ST. TAMMANY PARISH

Addendum No.: 4

Bid#: 19-01-2

Project Name: Lift Station and Blower Control Electrical Panels

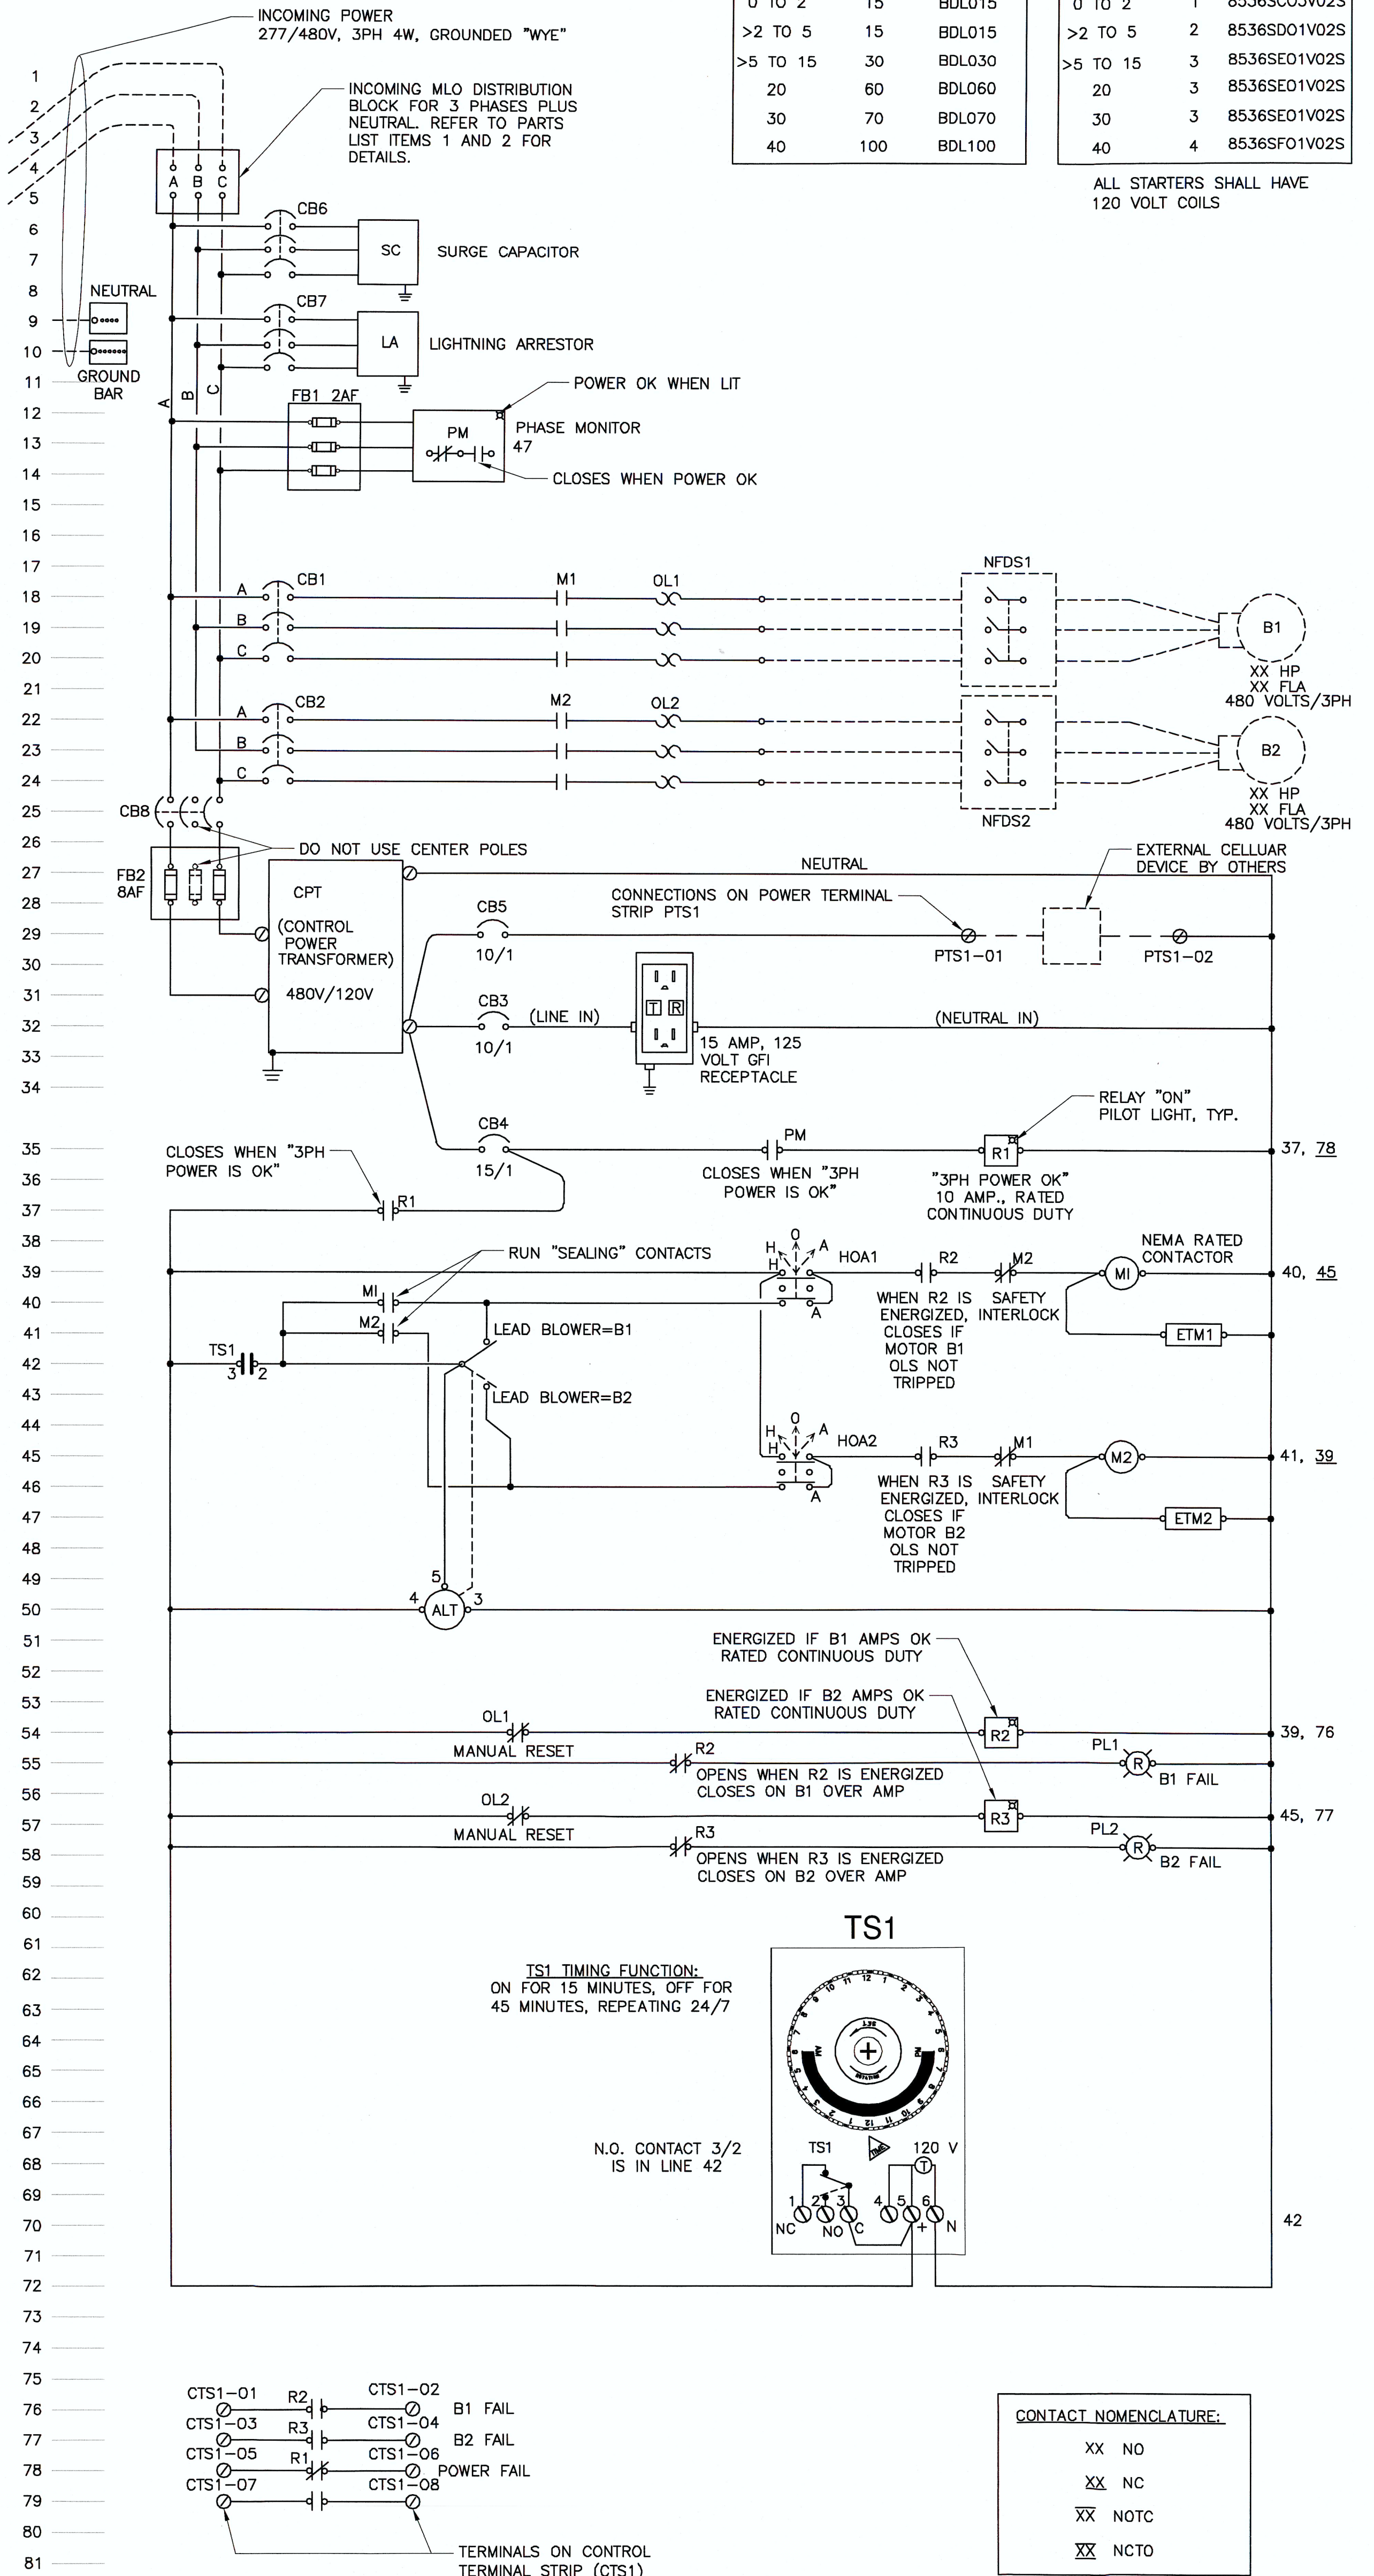
Question #1: For the blower bid, In the spec, you did not provide the starter or breaker sizing for 20, 30, 40, 50, 75 and 100 H.P. units. What are the sizes you want??

Answer #1: The starter and breaker sizes for 20 HP, 30 HP, and 40 HP have been specified on Attachment “C”-REVISED (Attached).

Bid Items Blower Control-011 (50 HP), Blower Control-012 (75 HP), and Blower Control-013 (100 HP) have been removed from the Bid and the Specifications and Pricing Sheet has been revised (Attached).
